CERTIFICATE OF APPROPRIATENESS

Application Date: December 2, 2014

Applicant: Adam Bakir, Incredible Renovations for Kelly A. Thomas, owner

Proposal: Alteration – Replace 22 historic wood 1-over-1 windows on both side elevations of the structure with wood 1-over-1 windows to fit within existing openings.

WINDOW	APPLICANT PHOTO	APPLICANT DESCRIPTION
E1a		Broken window sash
E1b		Broken window sash
E2	Glass Block

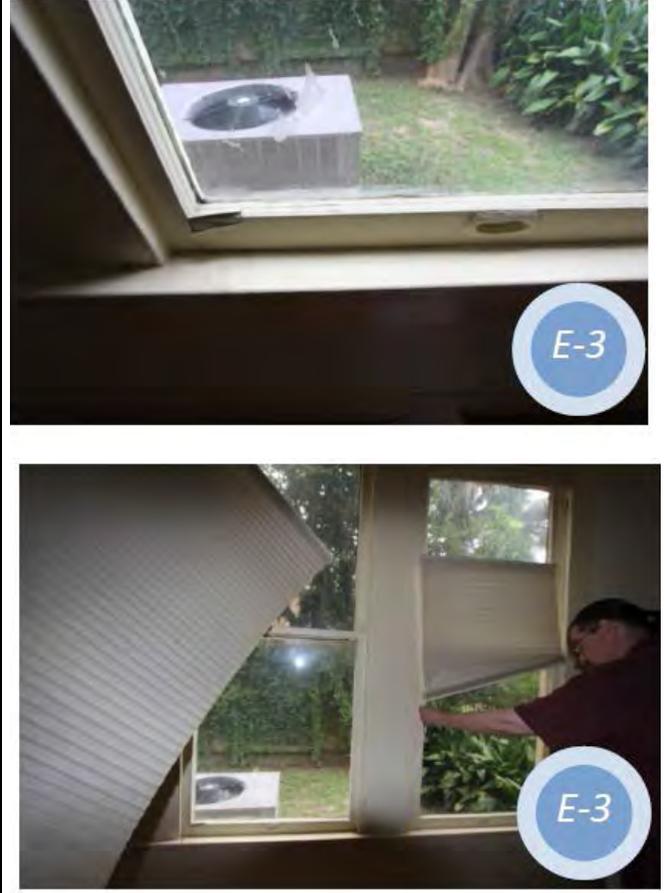
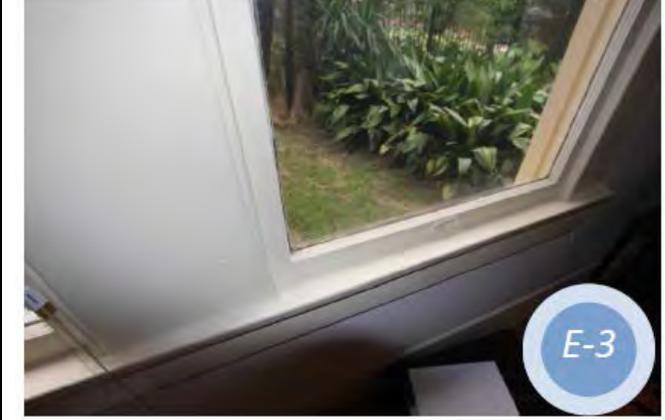
WINDOW	STAFF PHOTO	STAFF FINDINGS	RECOMMENDATION
E1a		Cracked paint; Painted shut	Repair. The 'broken sash' as indicated by the applicant appears to refer to the visible joint between the rail and stile, not to actual damage.

<p>E1b</p>		<p>Painted shut; flaking paint; meeting rail slipping slightly.</p> <p>Wood under flaking paint is solid.</p>	<p>Repair.</p> <p>The 'broken sash' as indicated by the applicant appears to refer to the visible joint between the rail and stile, not to actual damage.</p>
<p>E2</p>	<p>Glass Block</p>	<p>Not historic material</p>	<p>Okay to replace</p>

<p>E7c</p>		<p>Rotten window sash</p>
<p>E8</p>		<p>Broken window sash</p>
<p>E9a</p>		<p>Rotten window sash; Damaged window sill</p>

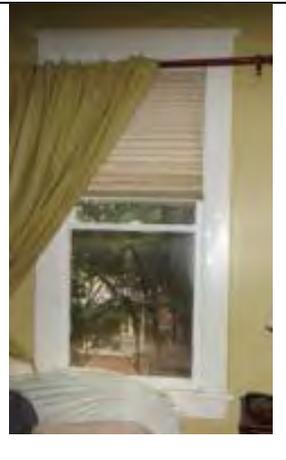
E8		Painted shut; meeting rail slightly dislocated but solid	Repair
E9a		Rotted bottom rail of lower sash; painted shut. Wood is solid underneath cracked and flaking paint on window trim. No sill damage as stated by applicant.	Replace bottom rail of lower sash or repair with a wood consolidant and filler.
